Appeal of an Administrative Decision to City Planning Commission

OLD RANCH ROAD STORAGE
Project Name

DEPN-22-0021
All File Numbers Associated with the Application

Appeal Statement for DEPN-22-0021

LIGHT FIXTURE AND PHOTOMETRIC SITE PLAN

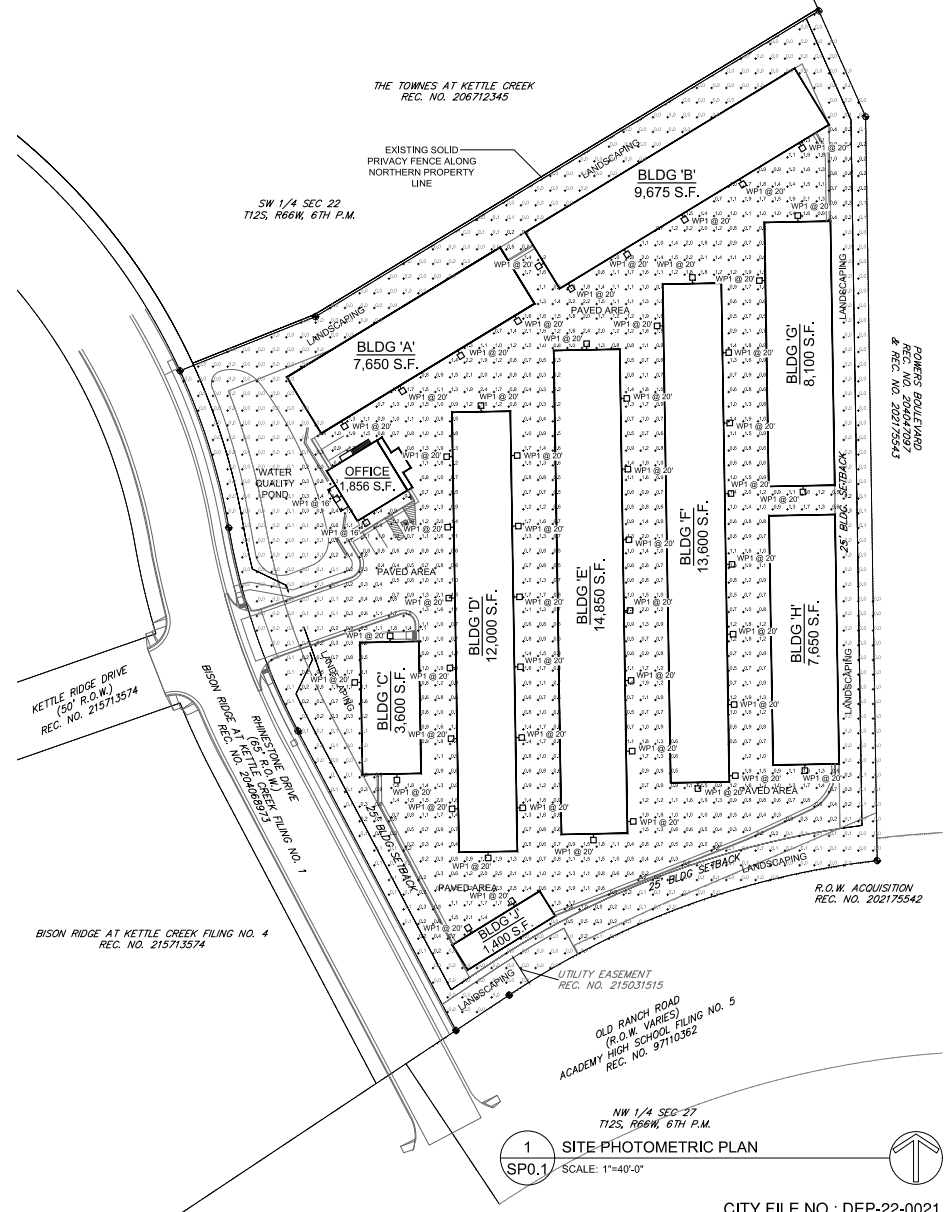
The applicant's lighting plan proposes the use of a variety of fixtures with a lumen output ranging from 1,000 to 3,000, all of which are downward-facing. However, it fails to specify the total quantity, placement, or cumulative photometric impact on the surrounding neighborhood. This omission is critical.

While individual fixtures may comply in isolation, the combined intensity of dozens of high-output lights, operating 24/7, represents a significant risk of light pollution, particularly to the adjacent residential properties to the north, west, and across Old Ranch Road.

Without a complete photometric study, including spillover analysis at the property boundaries, the City cannot accurately assess compliance with UDC requirements for site compatibility, buffering, and neighborhood protection.

Furthermore, the use of high-lumen commercial-grade lighting at the edge of a residential community is inherently incompatible with the quiet, low-light character of the surrounding area. At a minimum, the project must be required to:

- Submit a full lighting photometric plan,
- Implement shielded, low-glare fixtures, and
- Limit lighting operation hours to match restricted access hours.
